ADDENDUM #2

Sylvan Union School District

Standiford Elementary School Pavement Replacement Project & Site Improvements

BID #2021-22 #10

EXHIBIT "A"

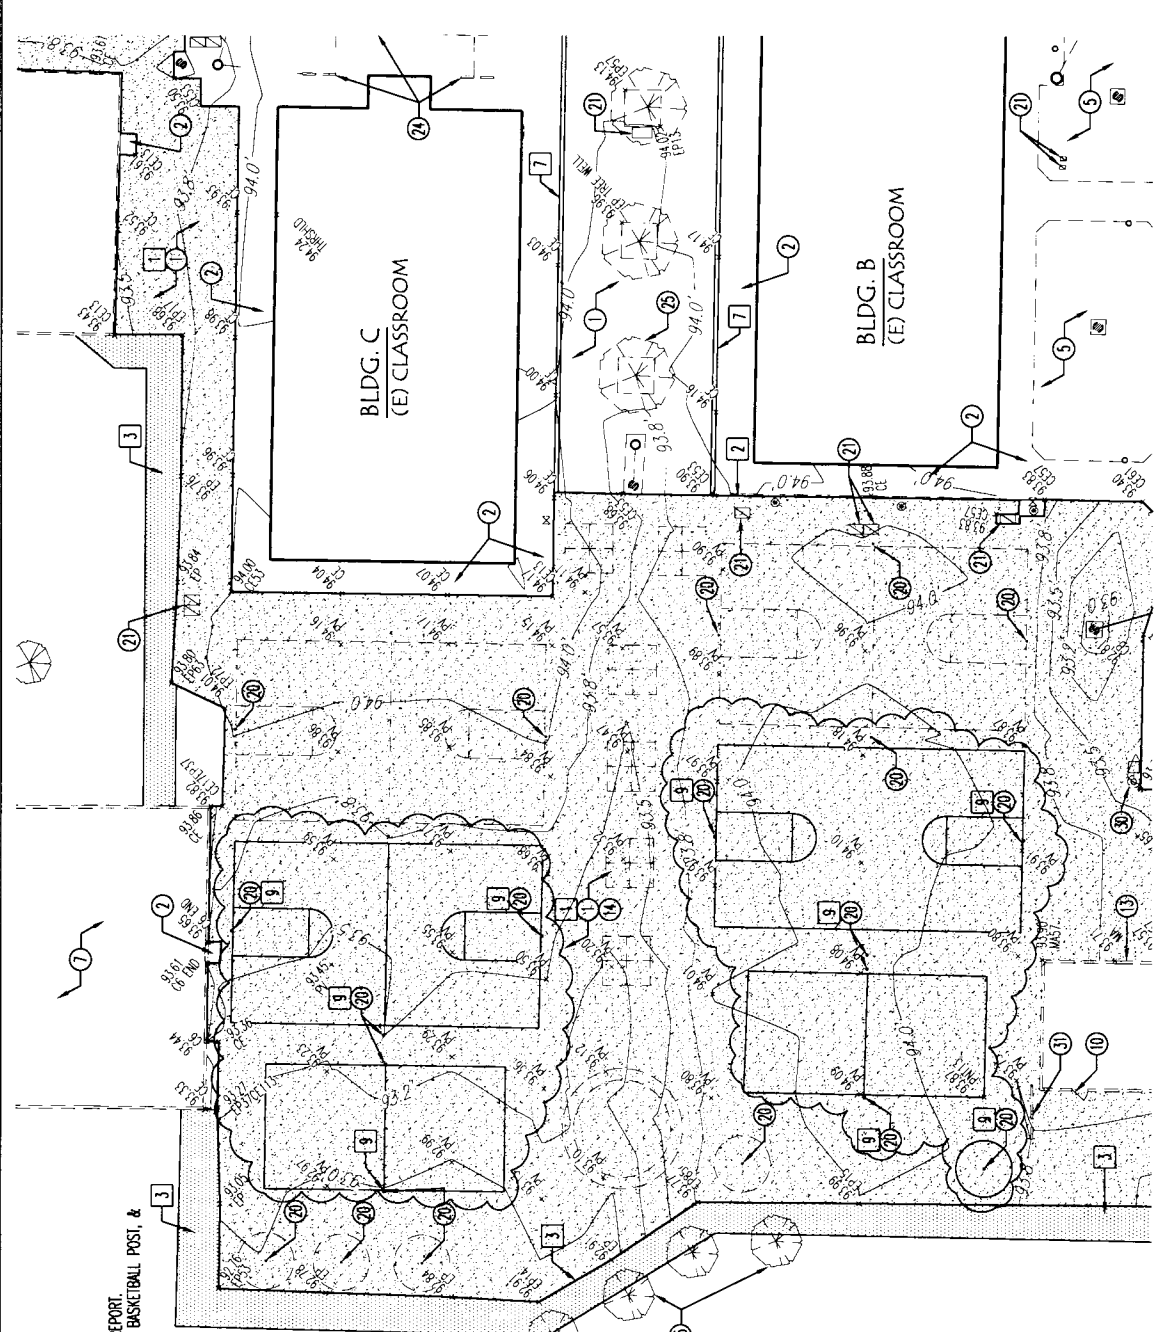
ITEM #1.1: Sheet C3.0 - Play Courts: Contractor demo and remove select basketball hoop posts, volleyball posts & tetherball posts. **See attached EXHIBIT "A"**

- 9 DEMO & REMOVE (E) BASKETBALL, VOLLEYBALL AND TEHERBALL POSTS & FOOTINGS.

EXHIBIT "B"

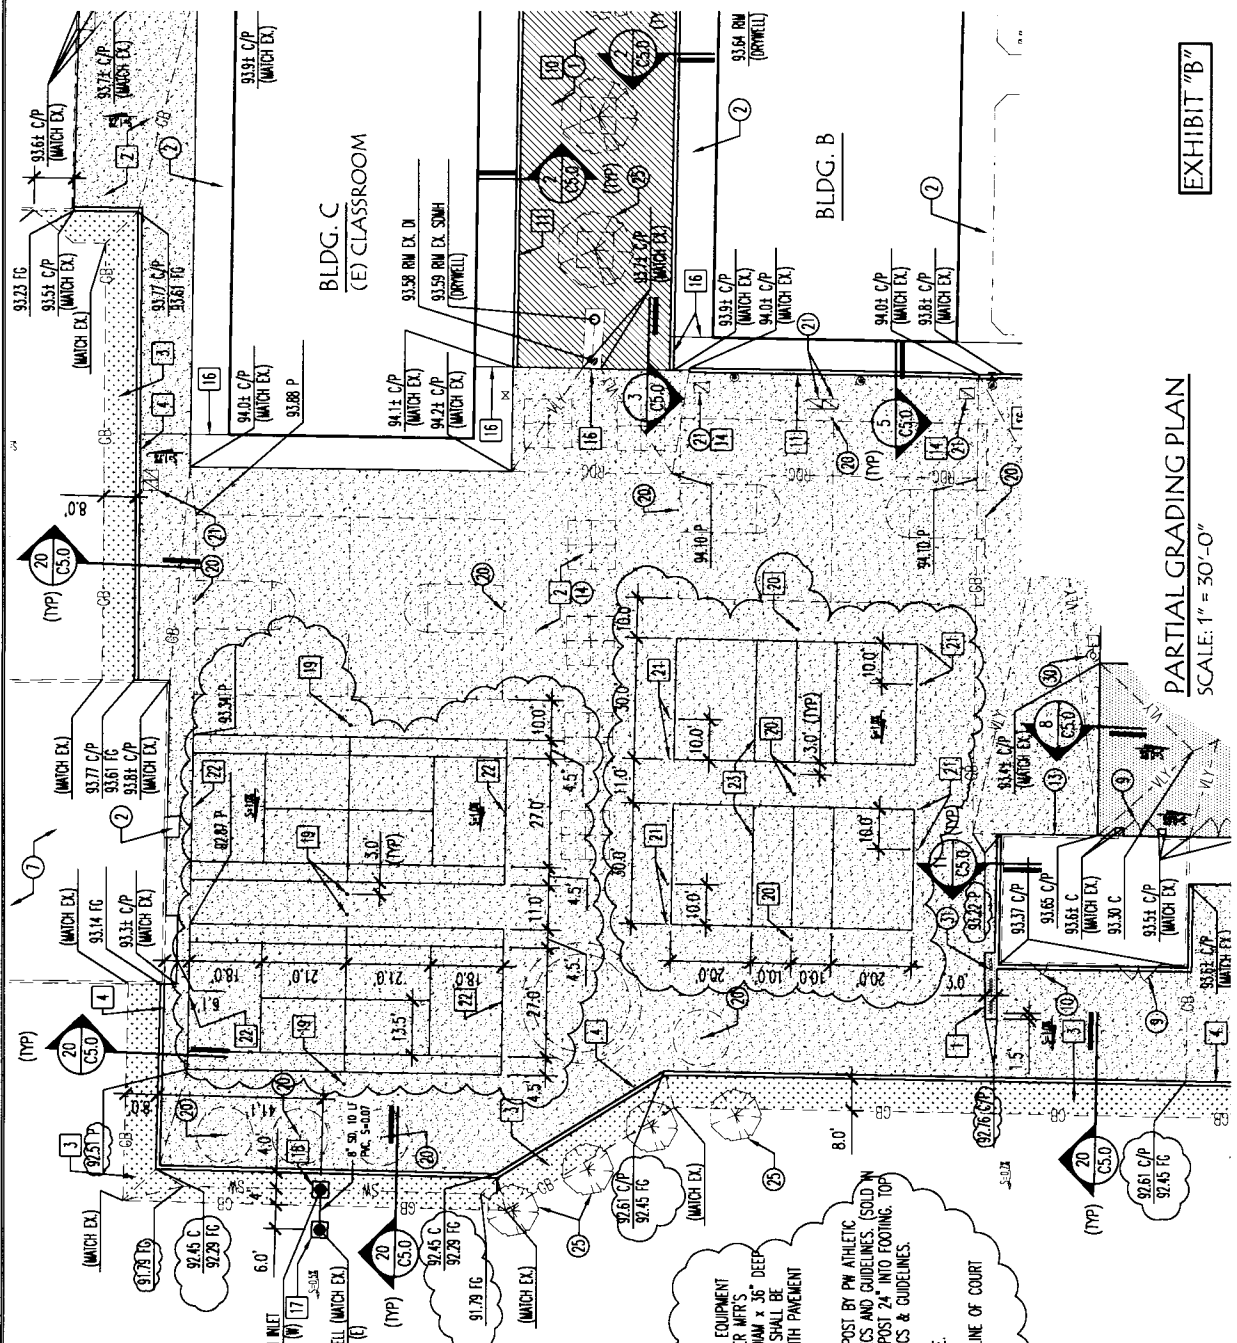
ITEM #1.2: Sheet C4.0 - Play Courts: Contractor shall install new volleyball, tennis posts and provide new striping for volleyball and tennis courts. Modify Grading Accordingly. **See attached EXHIBIT "B"**

- PROPOSED:**
- 19 NEW HEAVY DUTY 3" DAM TENNIS POST BY PM ATHLETIC EQUIPMENT (MODEL 2206-GR) POWDER COATED GREEN INSTALLED PER MFR'S SPECS AND GUIDELINES. (SOLID IN PARS) PROVIDE 30" DIAM X 36" DEEP FOOTING, EMBED POST 18" INTO FOOTING, TOP OF POST SHALL BE 42" ABOVE GRADE, BOTTOM EYEBOLT SHALL BE FLUSH WITH PAVEMENT PER MFR'S SPECS & GUIDELINES.
 - 20 NEW HEAVY DUTY GALVANIZED 2 7/8" DAM VOLLEBALL POST BY PM ATHLETIC EQUIPMENT (MODEL 2214-21) INSTALLED PER MFR'S SPECS AND GUIDELINES. (SOLID IN PARS) PROVIDE 30" DIAM X 36" DEEP FOOTING, EMBED POST 24" INTO FOOTING, TOP OF POST SHALL BE 8'-6" ABOVE GRADE PER MFR'S SPECS & GUIDELINES.
 - 21 2" WIDE X 6" LONG WHITE STRIPE, 'B' FROM COURT EDGE.
 - 22 2" WIDE X 4" LONG WHITE STRIPE, CENTERED ON BACK LINE OF COURT
 - 23 2" WIDE WHITE COURT STRIPING (TYP)

EXHIBIT "C"

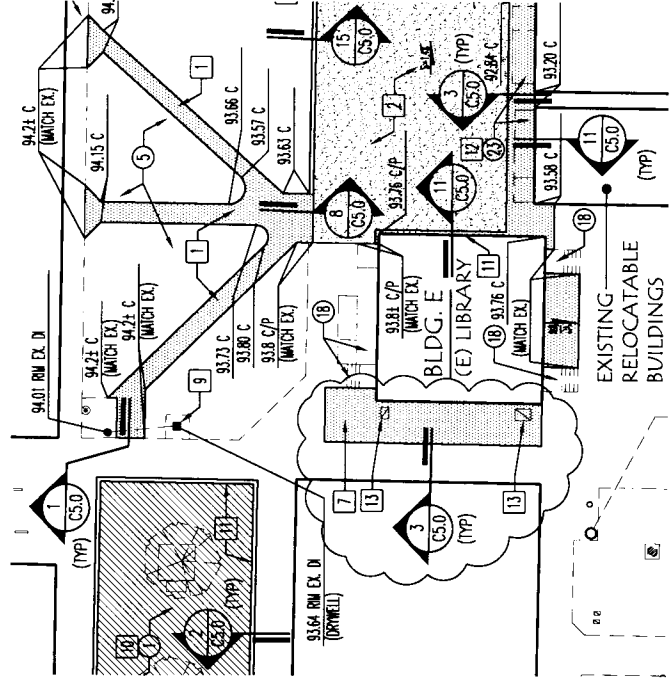
ITEM #1.3: Sheets C3.0 & C4.0 – Area West of (E) Library: Contractor shall remove existing pavement on west side of existing library and replace with new concrete **See attached EXHIBIT "C"**

- 7 REMOVE (E) PAVEMENT, INSTALL NEW 4" CONCRETE SLAB WITH #3 AT 18" O.C. EACH WAY, CENTERED IN SLAB OVER COMPACTED NATIVE (SSS), CONTRACTOR IS TO TAKE SPECIAL CARE TO PRESERVE & PROTECT FROM DAMAGE (E) UTILITIES / CONDUIT IN THIS AREA.
 -ADJUST ALL EX. UTILITY BOXES SHALL BE ADJUSTED TO NEW GRADE.
- 13 REPLACE (E) UTILITY BOX & PROVIDE CONCRETE CHRISTY BOX LID USE CHRISTY 840 BOX WITH CONCRETE READER LID, ONE STAMPED "GAS" AND ONE STAMPED "WATER"
